Questions/Notes from the Reading Turnback Committee Regarding the MBTA Turnback Track Sound Study

******Sound Study Scope & Calculation Questions******

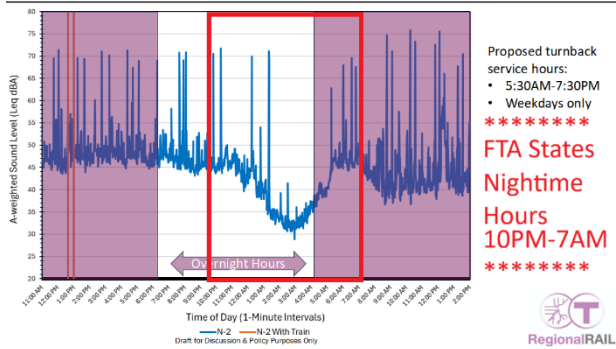
1. MBTA sound study has the Nighttime hours wrong (6:30PM-4:30AM), the FTA states 10PM-7AM, reference chart screenshot below.

2. Was the Nighttime 10-db penalty applied to each nighttime noise event, reference chart screenshot below?
 - a. It appears it was applied during the correct nighttime 10PM-7AM for Site N3, but was not applied to Sites N1 and N2.
- **Category 2** – The noise metric L_{dn} is a used for all category 2 land uses where nighttime sensitivity is a factor. This noise metric includes a 10-dB penalty for nighttime noise. See Appendix B.I.4.5 for more information on this metric.

Site N2 – Adjacent 88 Hancock Street

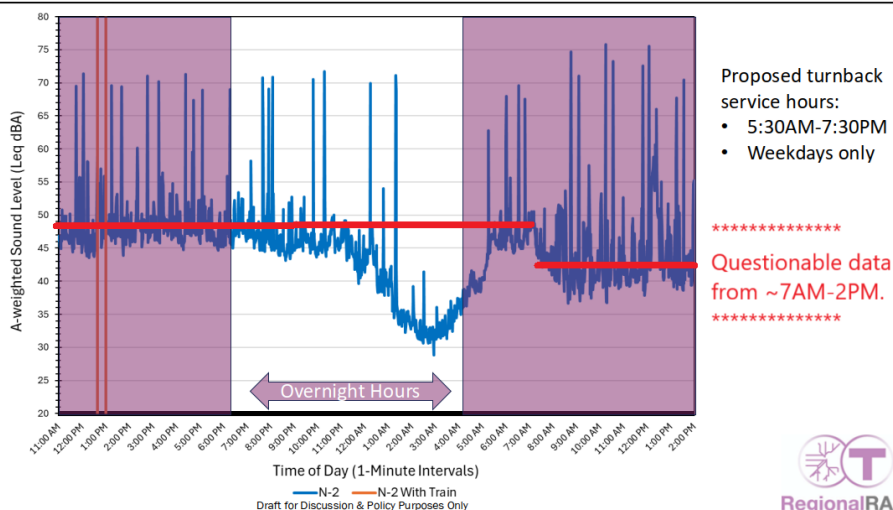
8. It appears there was a malfunction in all 3 Sound Devices around 7AM. If you draw and average line by eye from 11AM-7AM (excluding the nighttime dip) and the same from 7AM-2PM. The average dBA lines on all three charts drop approximately 5dBa.
 - a. This again calls into question the validity of the FTA/FRA Ldn dBa 24hr calculation.
